Proposal for Supplement 3 to the 03 series of amendments to UN Regulation No. 129

Submitted by the expert from the European Association of Automotive Suppliers*

The text reproduced below was prepared by the expert from the European Association of Automotive Suppliers (CLEPA), to introduce editorial changes in formal document ECE/TRANS/WP.29/GRSP/2019/12.

Figure 2

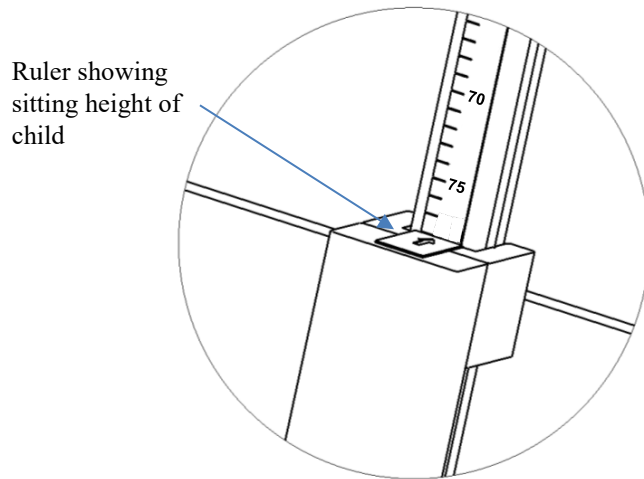
Amend paragraph 6.1.3.6., to read:

1. Editorial corrections Correction to paragraphs 2.3.4, 4.8.3 and to diagram in Figure 2 paragraph 6.1.3.6 and to the label in Annex 2, in ECE/TRANS/WP.29/GRSP/2019/12.
-

1. Arrangements of the approval mark

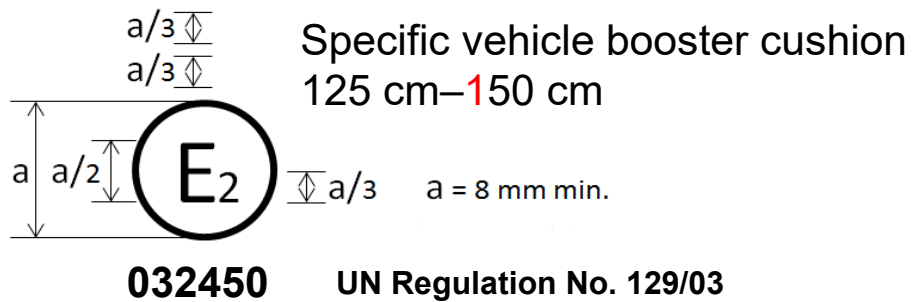
Annex 2, amend to read:
